PRODUCT BULLETIN No. 234
Commercial Gasket and Plectrum Update
Commercial – Architectural

Capral is pleased to announce the addition of a range of frame gaskets and an update to the pocket filler for the AGS commercial range.

- **400 Narrowline Series Framing System**

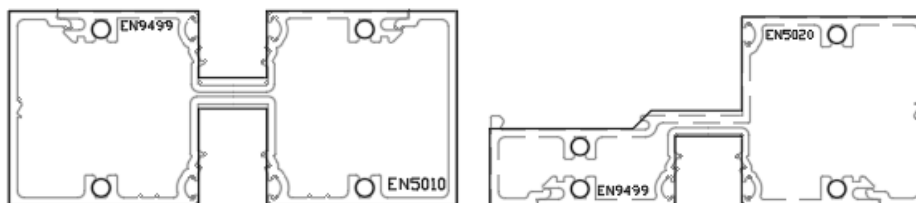
These Linen Impregnated Butyl material gaskets have been developed for the 300, 325 and 400 Narrowline framing systems. These gaskets enhance the sealing of the frames and provides time savings for the fabricator who no longer needs to silicone the frame joints.

Material No: 321149
Description: 400 Narrowline Sill/Transom Gasket
No. Of Adhesive Surface(s): 2
Pack size: 100 pcs/pack

Material No: 321150
Description: 400 Narrowline Sill/Transom Gasket
No. Of Adhesive Surface(s): 2
Pack size: 100 pcs/pack

Figure below illustrates the gaskets fitment onto the extrusions.

The existing 400 Narrowline Foam Gaskets are being discontinued:

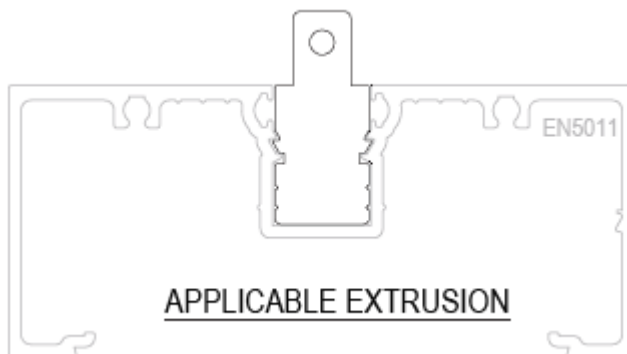
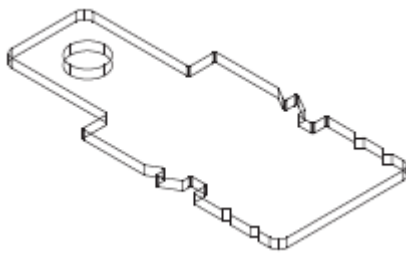
300160 - 400 FRAME FOAM GASKET 30.5M ROLL335

300161 - 400 SILL/TRANSOM FOAM GASKET ROLL205

These are now being phased out and once consumed will be replaced with the new Linen Impregnated Butyl gaskets.
